Southern California Edison Company

Subject: Docket No. 50-206
Instrumentation to Detect Inadequate Core Cooling
San Onofre Nuclear Generating Station
Unit 1

Reference: Letter, Charles M. Trammell, NRC, to Kenneth P. Baskin, SCE,
Instrumentation to Detect Inadequate Core Cooling, May 9, 1988

FIGURE 3-1

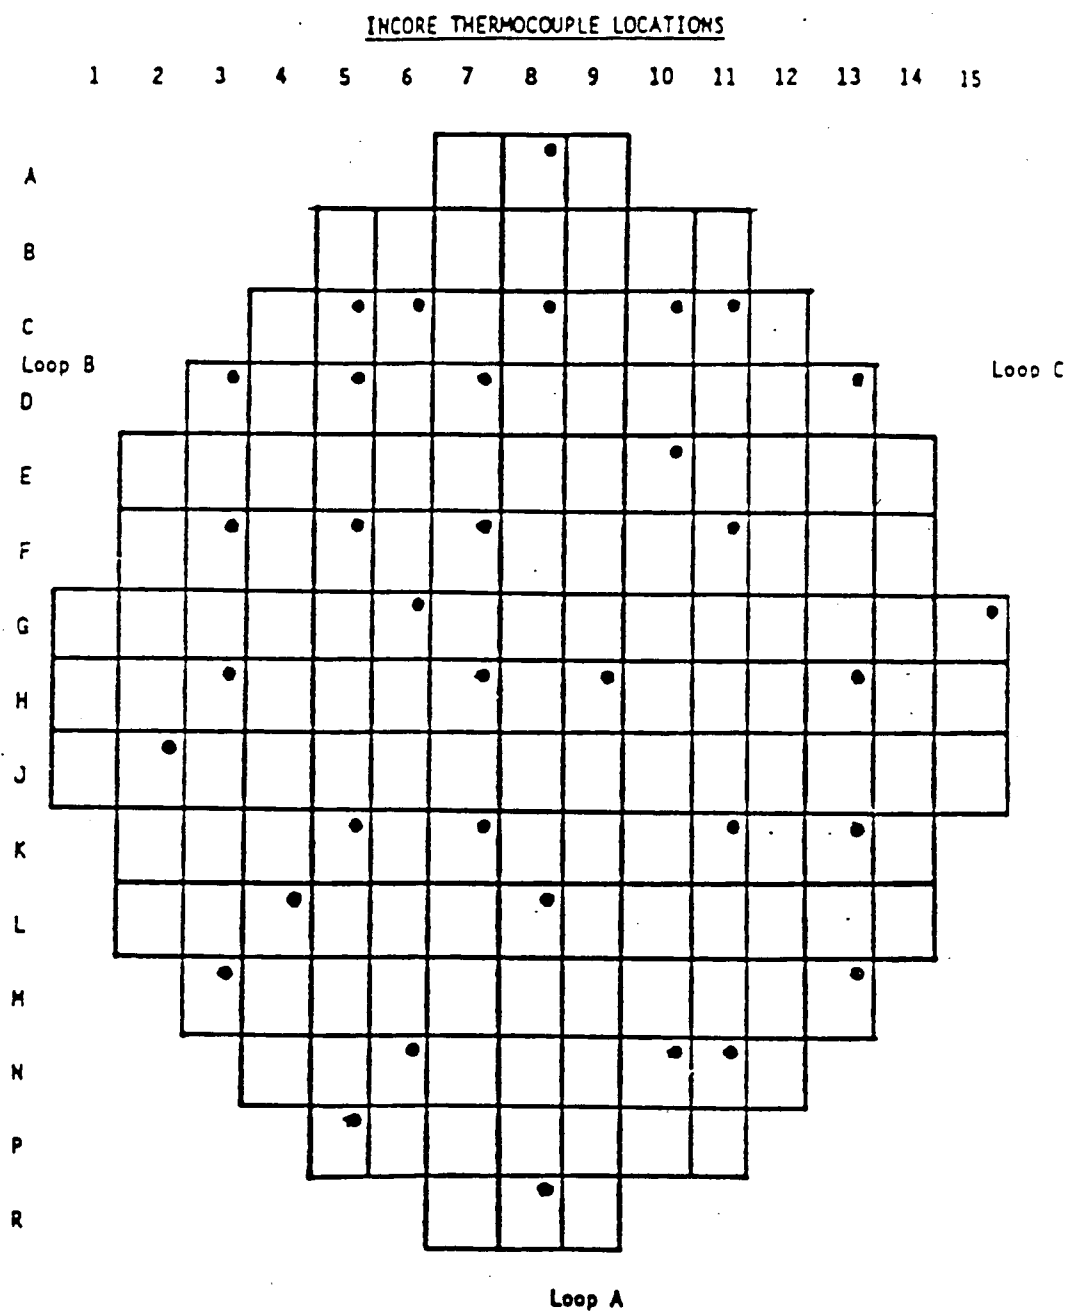
7. Can sixteen CETs, four per core quadrant, be read in less than six minutes by the backup display system?

Response: Yes. The backup CET display system can read out all of the CETs, with a distribution as illustrated in Figure 3-1 of the enclosure to SCE's June 20, 1986 letter, in approximately two minutes. Figure 3-1 is provided as Attachment 1 to this document for reference.
